MFN 05-109

**Subject: GE Response to Results of NRC Acceptance Review for ESBWR
Design Certification Application – Item 2 (TAC # MC8168)**

DCD Acceptance Review Item 2:

TRACG Applicability for the Feedwater Line Break

Figure 3-1. Feedwater Line Model for FWL Break Analysis

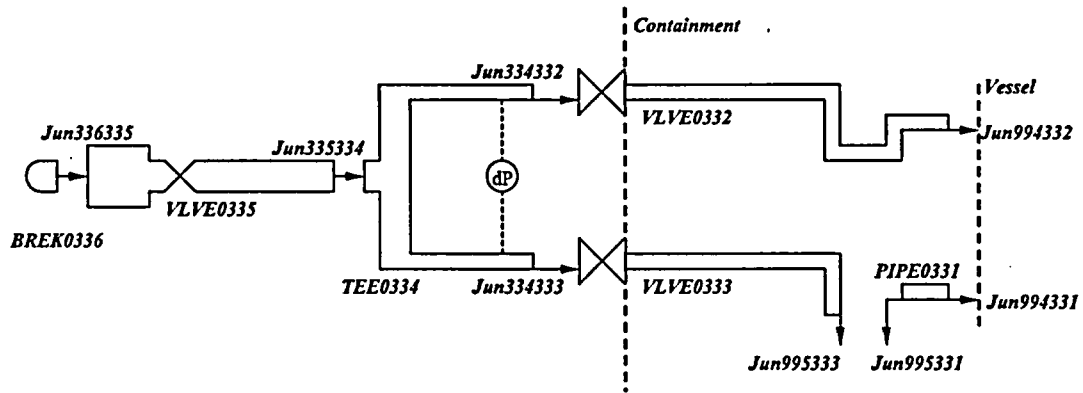
Provide design information to document that the largest possible feedwater line break location and area was considered. State the break area on both sides of the break. 10 CFR 50.46 requires that a spectrum of break sizes and locations be analyzed to demonstrate that the limiting break has been identified.

Figure 3-1 shows the schematic of the entire feedwater line model. The model encompasses the feedwater lines from the FW heaters to the RPV. Figure 3-2 depicts a single flow path that represents parallel trains of FW heaters and FW pumps in the Turbine Building. Elevations are conservatively assumed so that the inventory can be flashed into the containment through the postulated break location. Feedwater lines in the Steam Tunnel and in the containment are modeled with two loops: Intact Loop and Broken Loop, one for each 550 mm (22") main feedwater line in the steam tunnel and associated piping. Figure 3-3 shows a TEE component that represents the FW header in the Turbine Building and main feedwater lines in the Steam Tunnel. Two branches of TEE components end at the Isolation Valves near the containment boundary. Inside the containment, each 550 mm main feedwater line is physically connected to an arc-shaped header that also has three 300 mm (12") risers connected to the feedwater nozzles at the RPV. The flow area of the ring header is doubled to represent the branched flow and the three risers are combined in the TRACG model. Figure 3-4 shows the Intact Loop inside the containment. Figure 3-5 shows the Broken Loop inside the containment. A break is postulated at the connection of main feedwater line to the arc-shaped header in the broken loop. The break flow area is 0.1977 m^2 at each end. The break flow from the reactor is flashed through one of these areas and the break flow from FW heater, pumps and the Intact Loop is flashed through the other area. The break flow from the reactor is limited by the feedwater spargers inside the RPV. The total flow area of spargers associated with three feedwater risers is 0.08387 m^2 . The location of modeled spargers is indicated in Figure 3-5. Figure 3-6 shows the calculation for the assumed FW Line break area.
